**SUBJECT: Acceptance of the Final Environmental Impact Statement for the Puna Geothermal Venture Repower Project**

**SUBJECT: Supplement to Acceptance of the Final Environmental Impact Statement for the Puna Geothermal Venture Repower Project**

**Comments on the Draft Environmental Impact Statement of the Puna Geothermal Venture  
Repower project.**

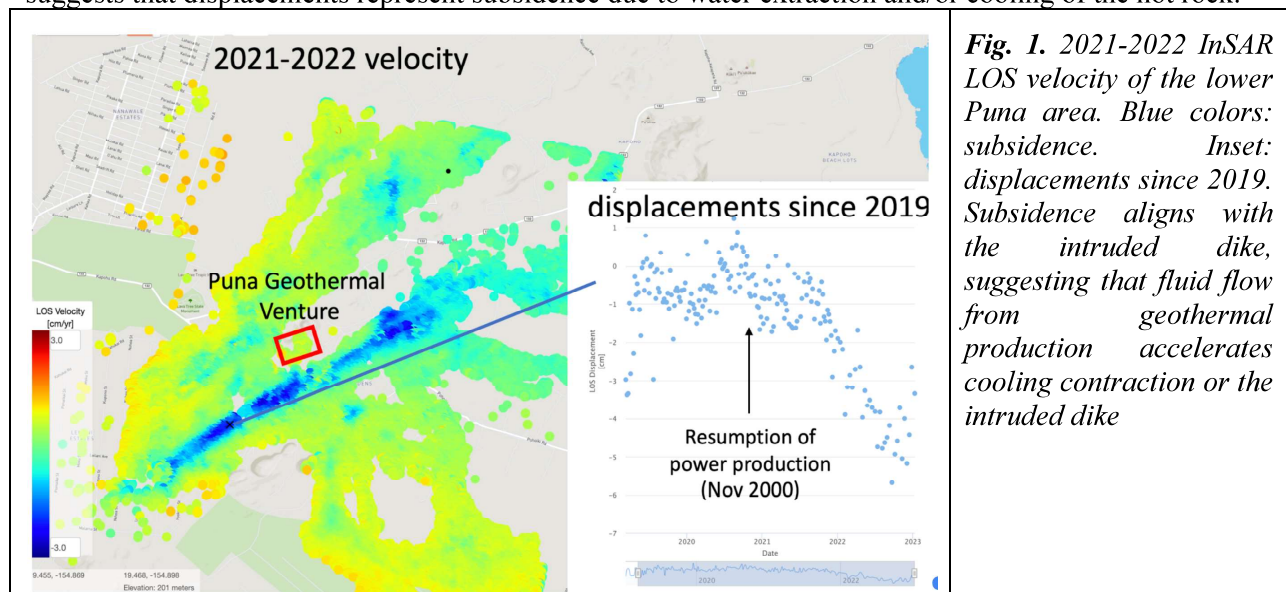
**Item 4: Subsidence from geothermal exploration in the lower Puna area.** In the draft EIS it is stated that there have been no significant changes in patterns or trends of deformation due to human activity in the PGV area, based on the Kauahikaua & Truesdell (2020) study mentioned above (section 3.1.1.3). This statement is not correct.

I processed InSAR time series data based on >100 Sentinel-1 SAR images which show for the 2021-2022 period a linear 50-200 meter-wide ground displacements feature in the area of the eruptive fissure at a rate of 2-3 cm/yr (~1 inch/yr) in direction of the satellite (Fig. 1). A displacement time-series starting after the 2018 eruption shows that ground displacements started in fall 2020 when PGV resumed production. This suggests that displacements represent subsidence due to water extraction and/or cooling of the hot rock.

The significance of the observed subsidence will not be known unless the proposed research project is conducted. Nevertheless, it is proof that PGV operations affect a larger area and highlight the need for high-quality seismic monitoring.
